MONUMENT GLAMPING SITE PI
16315 RICKENBACKER AVE.
MONUMENT, CO 80132

SITE PLAN

File No. PPR2443

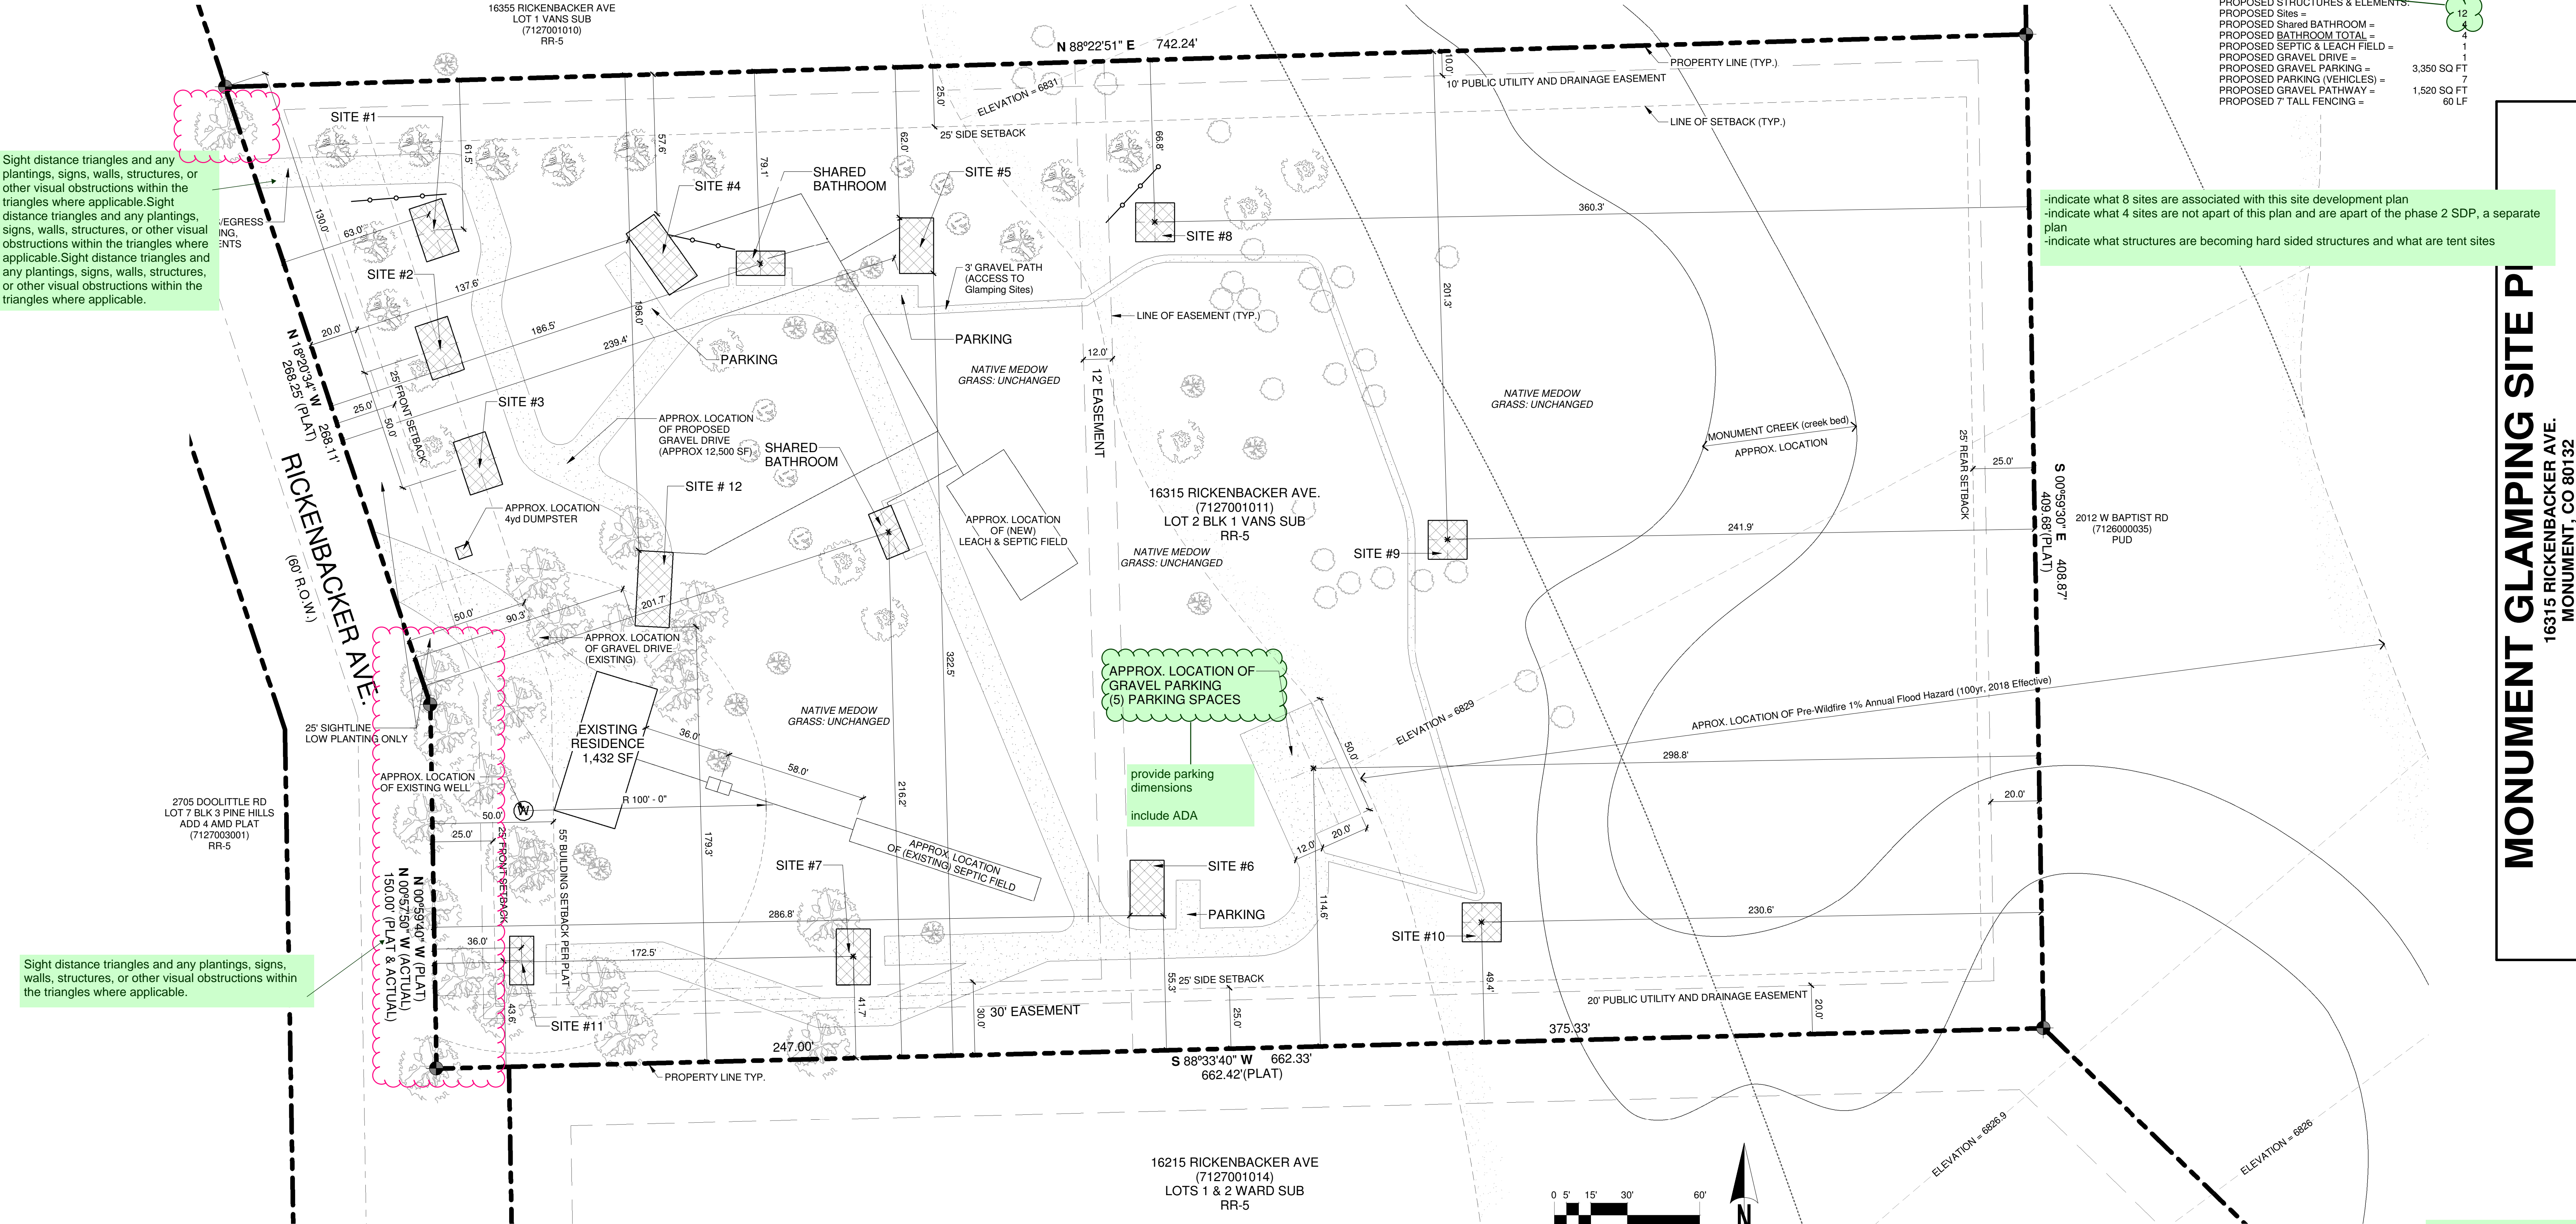
Sight distance triangles and any plantings, signs, walls, structures, or other visual obstructions within the triangles where applicable.

adjust this number to 8

-indicate what 8 sites are associated with this site development plan
-indicate what 4 sites are not apart of this plan and are apart of the phase 2 SDP, a separate plan
-indicate what structures are becoming hard sided structures and what are tent sites
